HOPE CREEK GENERATING STATION
DOCKET NO. 50-354
FSAR COMMITMENT STATUS THROUGH MAY 1984

Public Service Electric and Gas Company presently does not plan to issue Amendment No. 6 to the Hope Creek Generating Station Final Safety Analysis Report before July 1984. Accordingly, this letter is provided to document the status of Hope Creek Generating Station responses to NRC requests for additional information which were forecasted to be responded to by May 1984.

FIGURE 430.145-1 AMENDMENT 6, 06/84

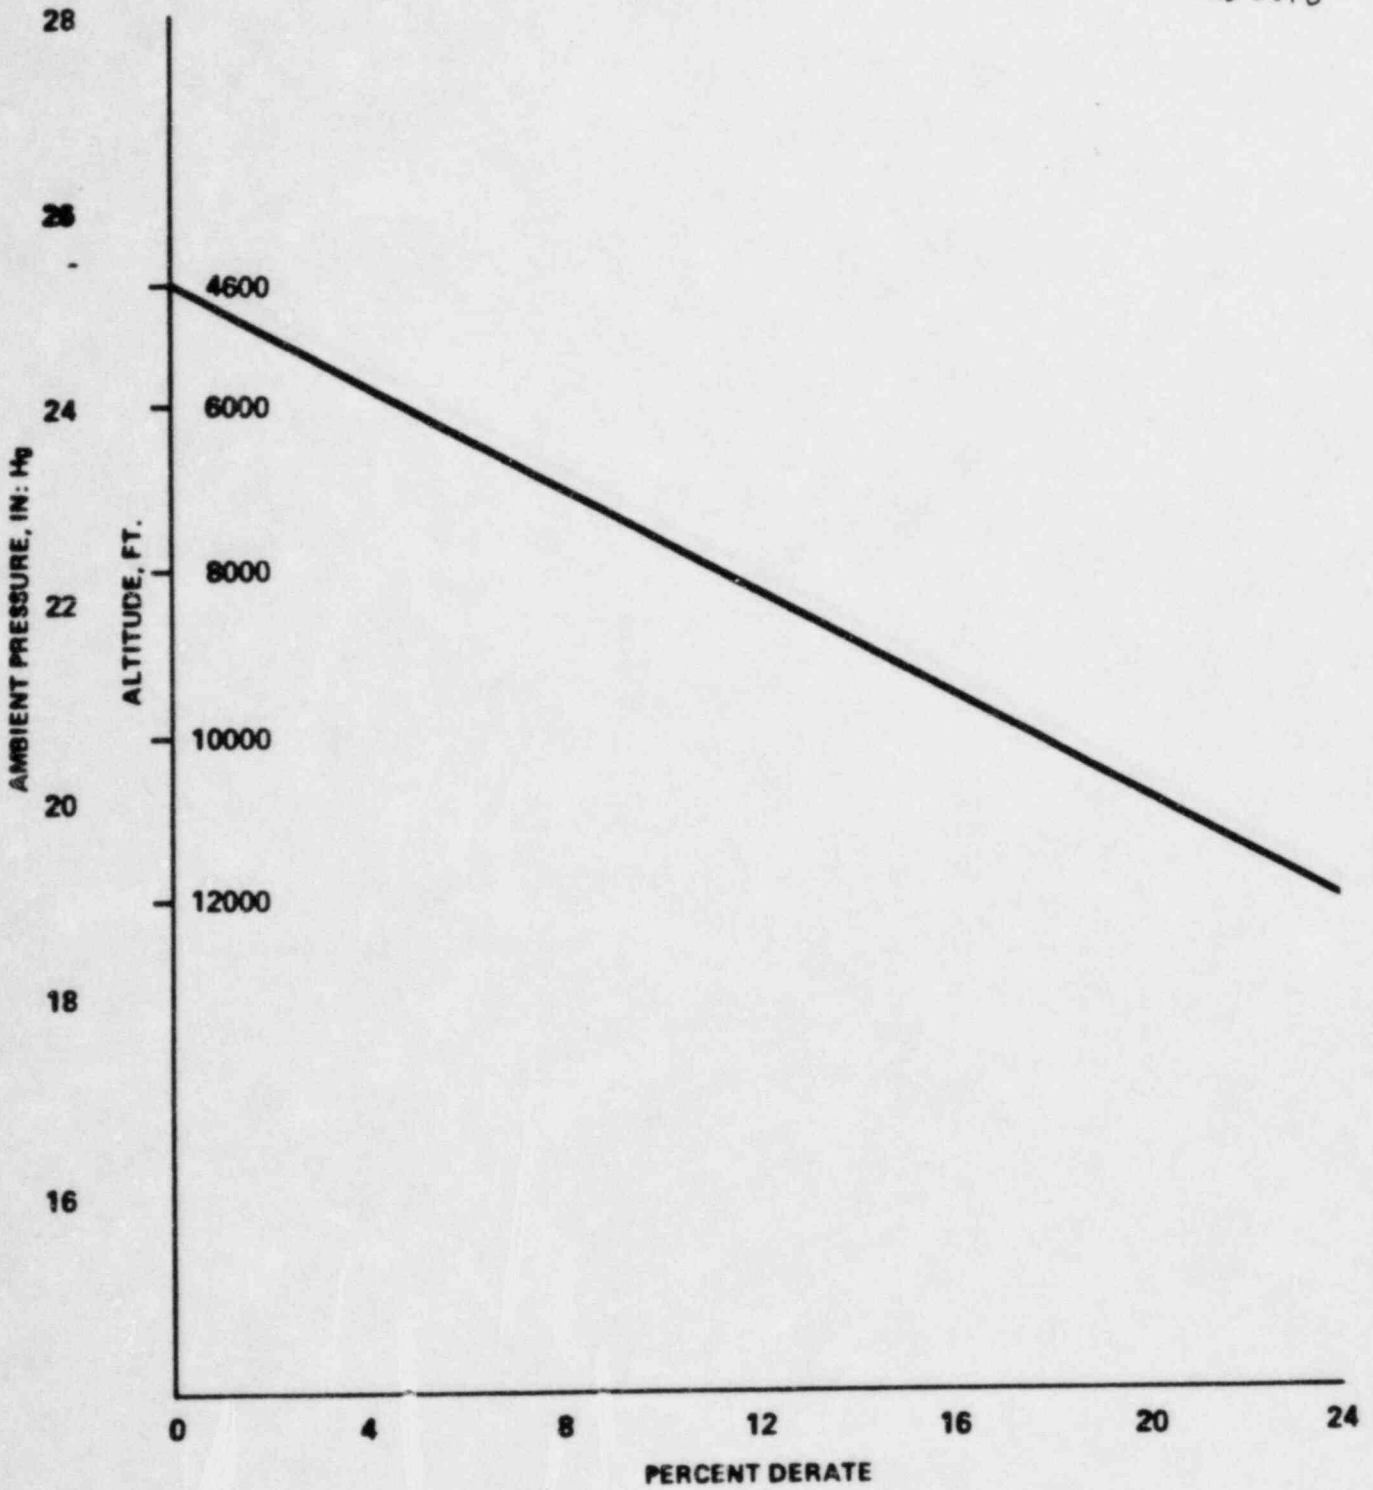
- d. Provide the manufacturer's design data for ambient pressure vs engine derating.
- e. Discuss the effects of any other service and weather conditions will have on engine operation and output, i.e., dust storm, air restriction, etc.
(SRP 8.3.1, Parts II & III; SRP 9.5.5, Part III, SRP 9.5.7, Parts II & III; and SRP 9.5.8, Parts II & III)

- d. A curve of the 12CR.PC2 class engine derating for ambient pressure (altitude) is attached (Figure 430.145-1). It should be noted that this curve is applicable on the long term basis - altitude derating - and is not applicable to short term phenomena such as tornadoes, hurricanes, tropical storms, or other weather depressions.
- e. The diesel engine manufacturer confirms that as long as the unit is adequately maintained (air intake filters kept cleaned, etc), there are no other conditions adverse to the engine.
